[Docket No. 2001-SW-50-AD]

**Airworthiness Directives; Eurocopter France Model EC120B, EC155B, SA330F, SA330G, SA330J, AS332C, AS332L, AS332L1, AS332L2, AS350B, AS350BA, AS350B1, AS350B2, AS350B3, AS350D, AS355E, AS355F, AS355F1, AS355F2, AS355N, AS365N2, AS365N3, SA-365N, and SA-365N1 Helicopters**

**ACTION:** Notice of proposed rulemaking (NPRM).

Figure 1

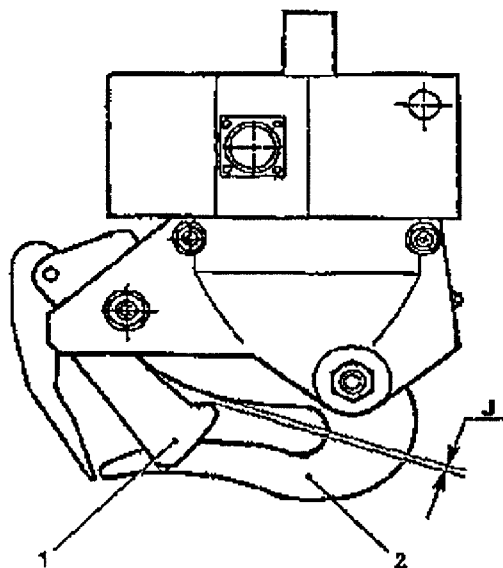
(a) With the cargo hook in the no-load position, measure the clearance "J" in accordance with Figure 1 of this AD. Remove any cargo hook if clearance "J" (see Figure 1) is equal to or greater than 14 millimeters (0.55 inches).

Clearance "J" must be less than 14 mm (0.55 inches)
